| <b>Technical Report</b>                |                               |                        |  |
| <b>Application No:</b>                 | <b>PA19/767</b>               |                        |  |
| <b>Address:</b>                        | <b>543 King Road, Oldbury</b> |                        |  |
| <b>Proposal:</b>                       | <b>Transport Depot</b>        |                        |  |

Stormwater Management

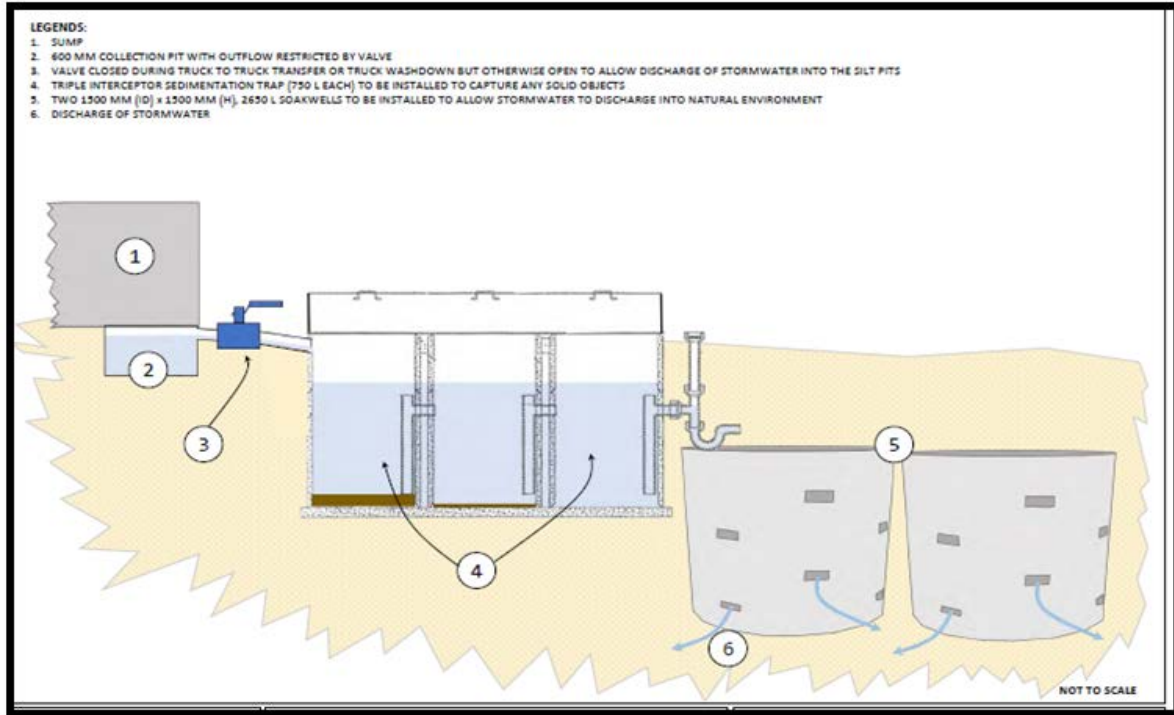
The applicant has prepared a site specific Storm Water Spill and Wash Down Management Plan which depicts an asphalt raised dedicated parking hardstand of 34m x 47m for the commercial vehicles and a 10m x 47m hardstand solely for the purposes of liquid waste transfer and vehicle washing.

A portion of the hardstand area where liquid waste transfer and vehicle washing is proposed to occur, will be bunded by a 200mm raised concreted kerb. This portion of area will be graded towards a wastewater sump to capture any wastewater runoff, to be then pumped out and disposed of. The purpose of the kerbing and hardstand area seeks to prevent hydrocarbons and possibly other contaminants leaching into the environment.

Officer note that bunding does extend to the entire perimeter of the hardstand area. This includes the parking area of the commercial vehicles, and thus any built up or spilt hydrocarbons within this area could impact the surrounding environment.

Further to this, a stormwater pit (soakwells) is proposed to be located at the base of the wastewater sump, which is proposed to capture stormwater run-off from the 10m x 47m dedicated hardstand areas. This is proposed when the wastewater sump is not being used as part of the liquid waste transfer process or when commercial vehicles are not being washed. This relies on a lever to be open or shut subject to the activity occurring at the time. The wastewater sump is thus sized for collection and containment of contaminated water that could occur with activities of truck to

truck transfer or cleaning, with this wastewater sump cleaned after such occurs. Outside these activities however, stormwater is intended to flow 'through' the system and infiltrate once passing through sediment traps, via the end of system stormwater pit (soakwells). This is shown following. Area (2) is the wastewater sump, which will also have a flow through of stormwater before existing at (6).

This practice is not considered optimal, and officers note DWER guidance does not support inline management of two different water quality flows. Officers have identified concerns over the possibility of contamination occurring to stormwater as a result of the stormwater pit being located at the base of the wastewater containment sump, albeit with a degree of treatment between the two. While noting this 'treatment' train, the fact liquid waste is being proposed in this operation means that risk management should demonstrate avoidance of such interaction, consistent with DWER WQPN guidance.

Officers also note that there is no dedicated sump, for stormwater purposes, for the larger hard surfaced area (34mx 47m) to capture and treat stormwater. Officers also note concern of the storage of the 2 skid mounted tanks on this area.

Proposed Raised Kerbed Hardstand Area

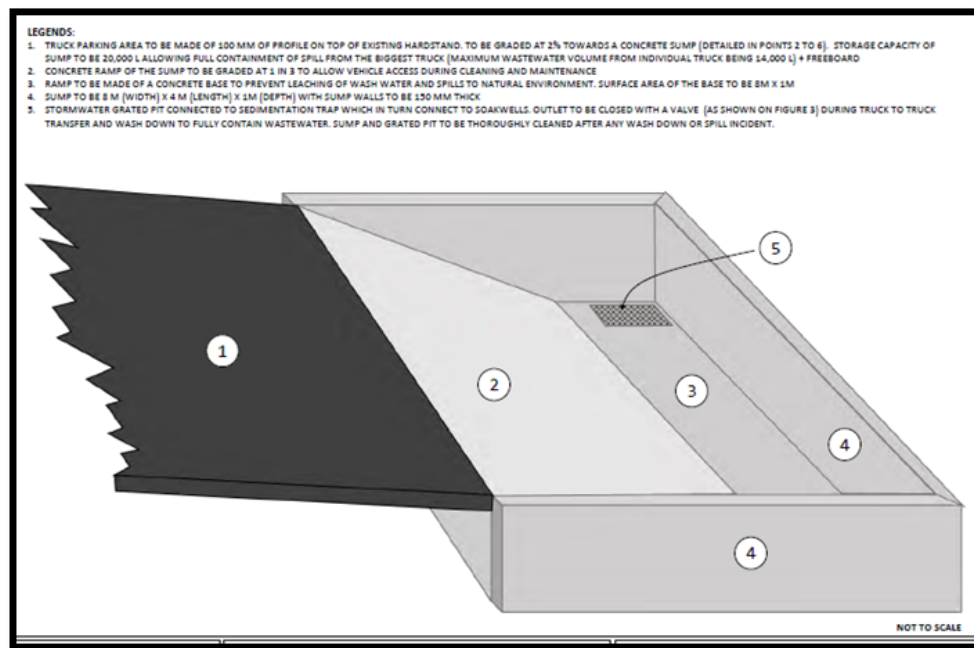
The dedicated hardstand area for this purpose is 10m x 47m in size and is impervious in nature. It consists of 100mm of profile (asphalt surface) on top of the existing surface. The area where liquid transfer and vehicle wash down is to occur will be graded at 2% towards a concrete wastewater concrete sump for spill and wastewater containment. The sump is designed for a spill volume capacity of up to 20,000L allowing full containment of a spill based on the largest truck container onsite, but relying on such being always empty and available for full use. The hardstand area where the transfer of liquid will occur will comprise of 200mm raised concrete bunds around the perimeter for the hardstand area.

An area of 34m x 47m hardstand has also been dedicated for the parking of commercial vehicles and the skid mounted tanks, which is proposed to be constructed of the same profile as the transfer of waste and vehicle wash down area. It is noted, however, that this hardstand area is not bunded.

In terms of stormwater, a stormwater pit (soakwells) is located at the base of a wastewater containment system, in line with that system at its end point. Stormwater runoff from the 10m x 47m hardstand area will thus flow through the wastewater containment system – this is a key planning concern. It is also noted that there is no area proposed to capture stormwater runoff from the larger 34m x 47m hardstand area, representing a further planning concern.

Spill and Wash Water Containment

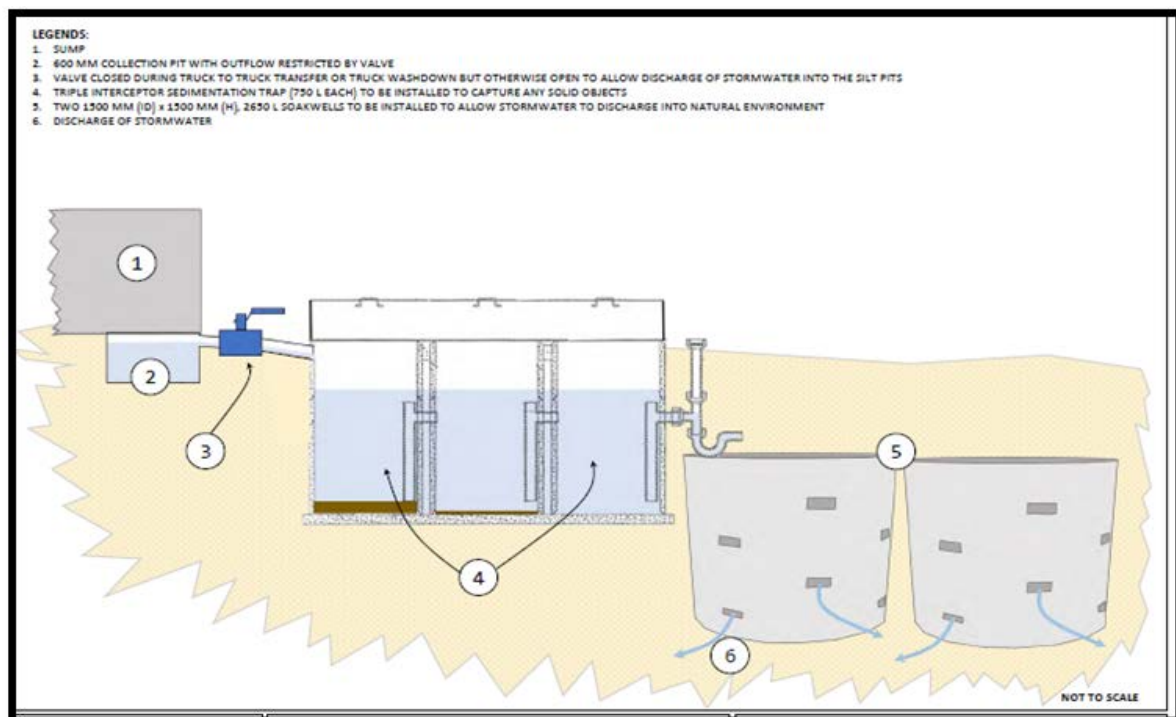
Stormwater Management

Officers raise concerns over the proposed methodology to contemplate interaction between wastewater and stormwater within the same system.

To minimise risk, a more optimal solution would be to always separate stormwater and wastewater processes to ensure that only clean stormwater physically capable of being released into the environment, and cannot mix with contaminated water. This is not currently proposed.

Water Protection Quality Note (WQPN) 52: Stormwater Management at Industrial Sites recommends that *“uncontaminated stormwater runoff from roofs, paths and the landscape should not be allowed to mix with process effluent, stored chemicals or stormwater runoff from areas susceptible to chemical spills. Where practical processing areas involving the use of chemicals should be weather proof or covered”*.

In this regard, the proposed wastewater sump relies upon a lever to open during those processes of transfer or cleaning. The wastewater sump is sized for the maximum truck volume, and thus also relies on it being completely empty and not having any residual water in there already, such as from low frequency rainfall events. Outside transfer and cleaning, stormwater can flow through the sump to the end of line stormwater pit (soakwell).

There is the possibility that stormwater in some instances could collect residue of liquid waste from wastewater sump, providing a pathway for contaminants to leach into the environment. Also, small rainfall events could inadvertently reduce the capacity of the wastewater sump, posing a risk to the environment also.

These risks render the application unacceptable for approval.
